Technical Notice

Engineering Change Notice for 00.00.15.357787 Software

TN S/N: TN-JY-2406001

ECN Number: ENIA5A0001

Software information after successful upgrade

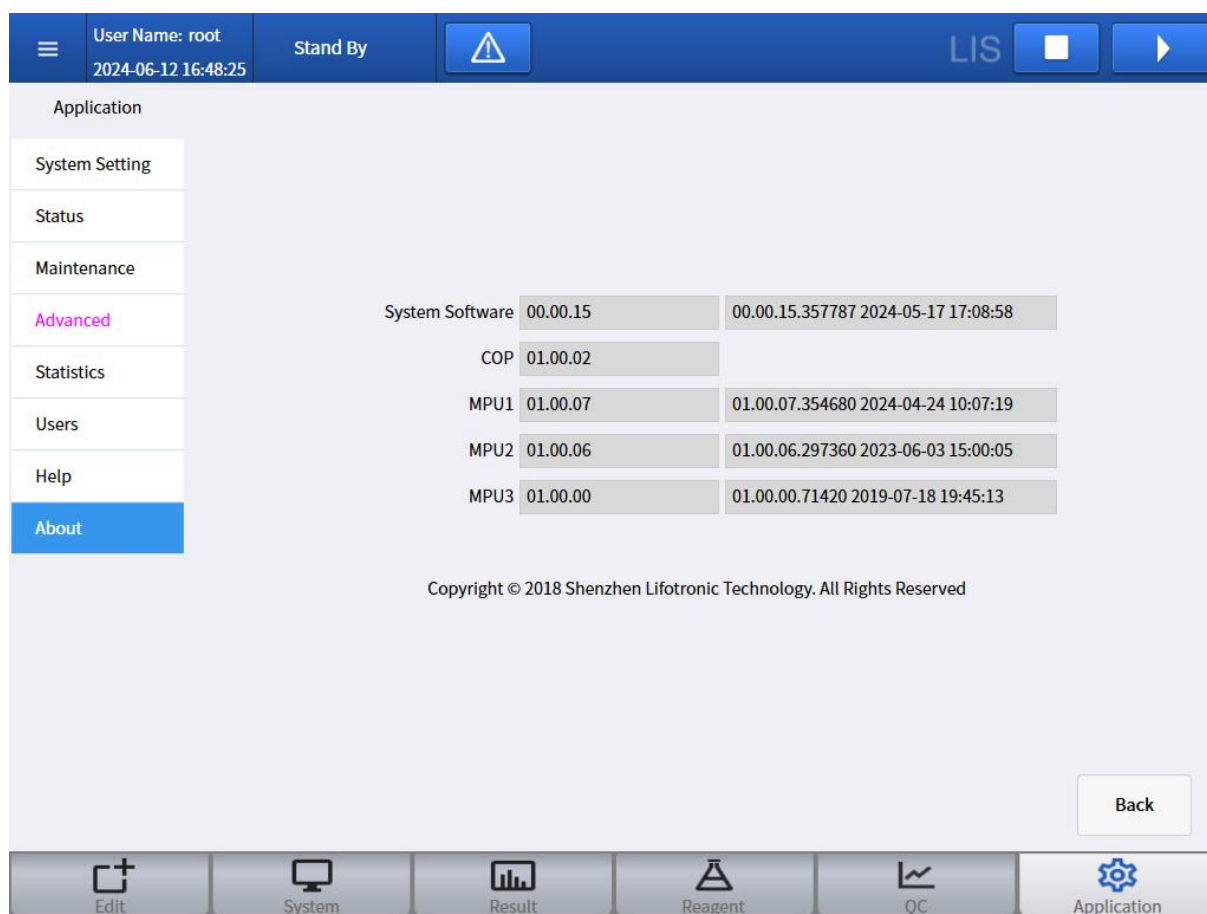
Note: The COP version remains unchanged. Please skip the COP upgrade procedure. If the MPUs versions are the same, upgrading for MPUs are still needed.

Interface Path: Application → System Settings → Software Setting → Item Setting → Retest Set

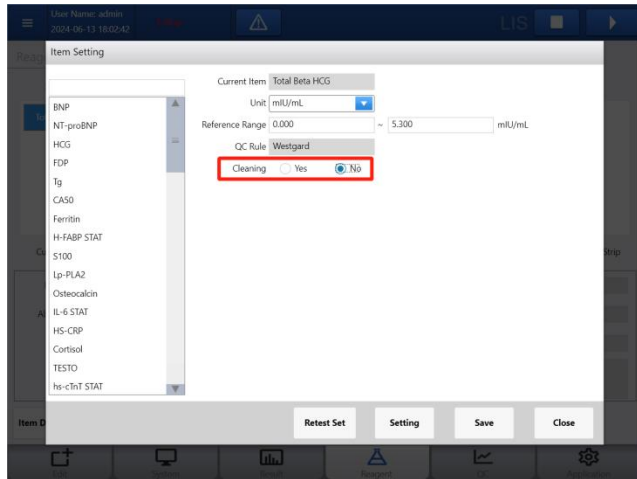
4. The automatic retest function of the old version has defects and cannot meet the testing requirements in some usage scenarios.

4. Optimize the automatic retest function. Add automatic retest screening conditions. When the test result is lower or higher than the set values, the sample will be retested according to the corresponding set retest dilution ratios.

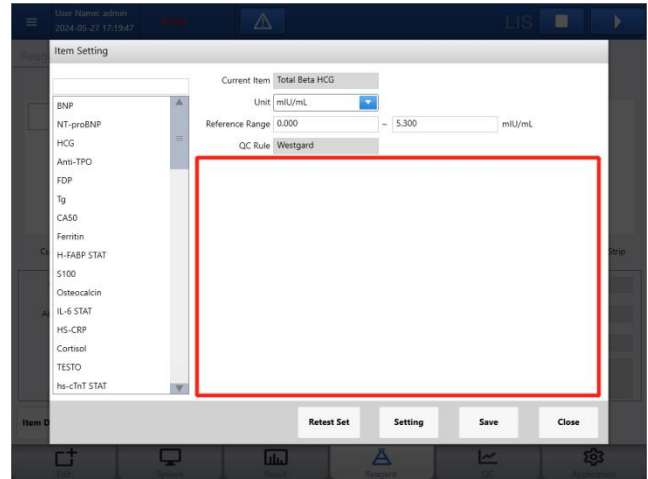
6. All accounts have the authority to enable the enhanced cleaning program.

The admin account, which has the second-highest authority after root, is used for demonstration here

6. Added restriction that only the root account has the authority to enable or disable the enhanced cleaning program.

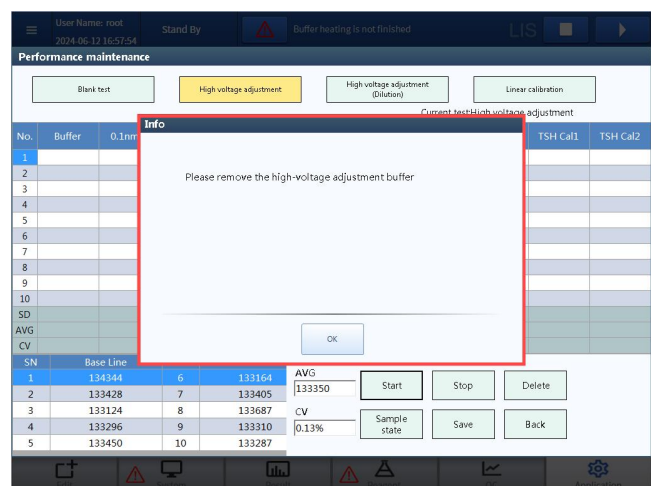
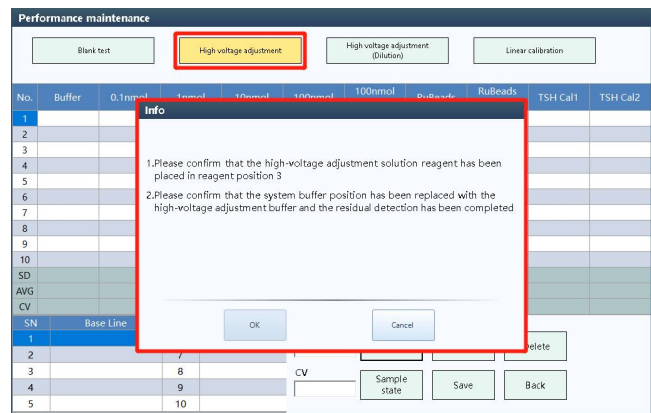
7. No such prompt.

7. Added prompts on using related reagents before and after performing High-voltage Adjustment test.

Interface Path: Application → Advanced → HD Setting → System Volume Offset

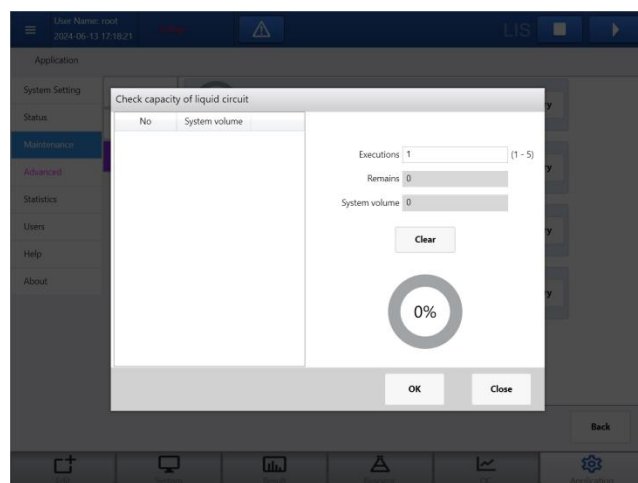
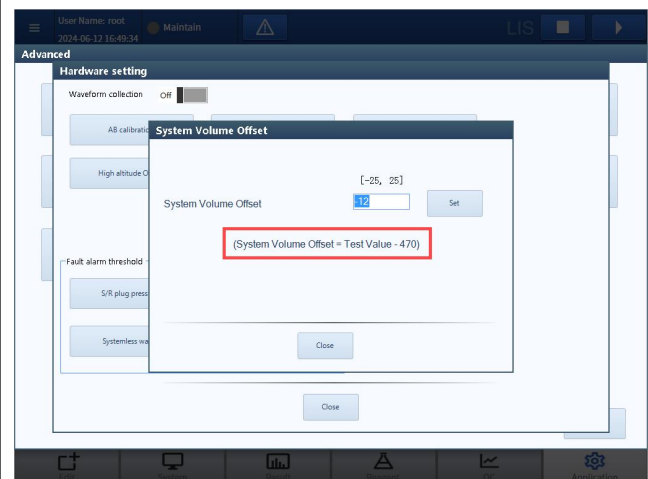
8.1. The calculation formula is not displayed on the System Volume Offset function interface (no examples to show here).

8.1. A calculation formula prompt 'System Volume Offset = Test Value - 470' has been added to the System Volume Offset.

The usage scenario is that when the system volume values are within the adjustable range, the manual offset can be adjusted to around 470.

Interface Path: Application (login with root account) → Maintenance → Maintain Instruction → Service Maintain → Check capacity of liquid pathway

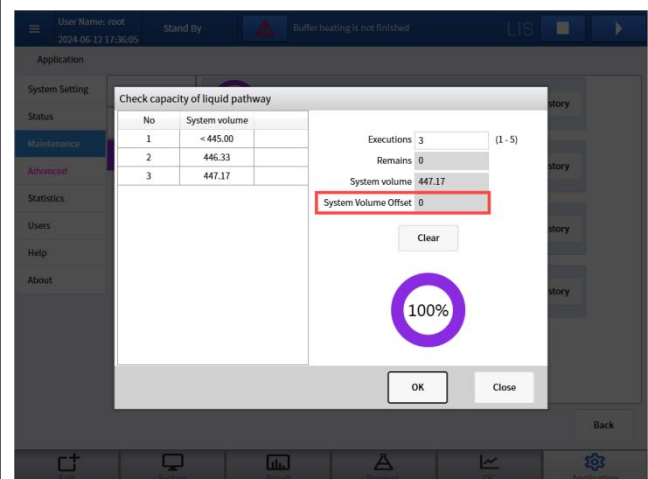
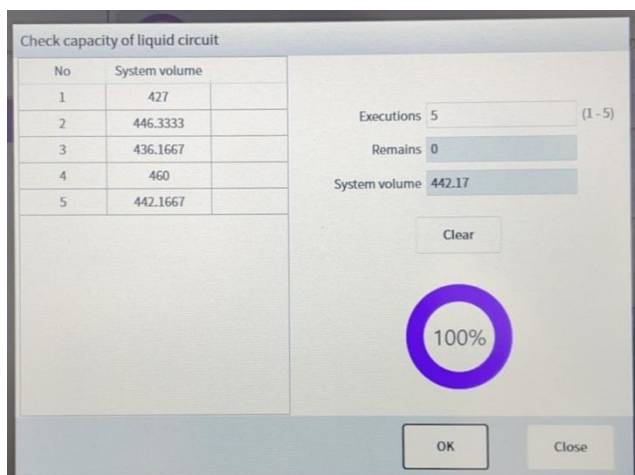
8.2. There is no System Volume Offset value column in the Check Capacity of Liquid Pathway (System Volume) test interface.

8.2. A System Volume Offset value column is added to the Check Capacity of Liquid Pathway (System Volume) test interface, through which the current offset value can be inspected.

Here <445 is taken as an example

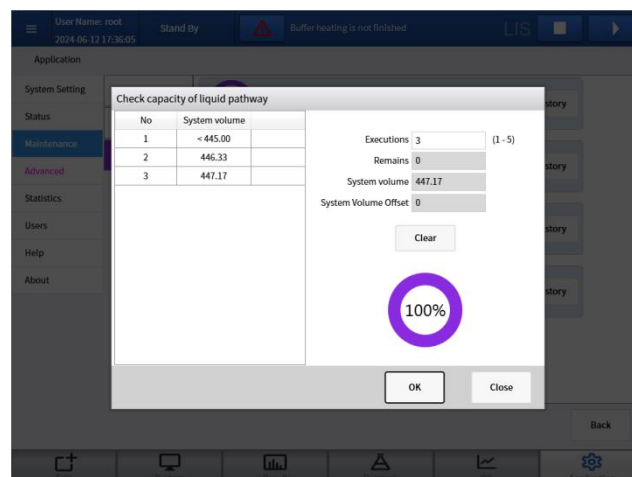
9. System volume test results are actual test values.

9. Optimize the display of system volume test results. Results within the range of 445~487 will display values, and results outside the range will display <445 or >487.

**Note: When the system volume result exceeds 445~487 or unstable, the offset function cannot be used for adjustment, it is necessary to check the instrument hardware.*
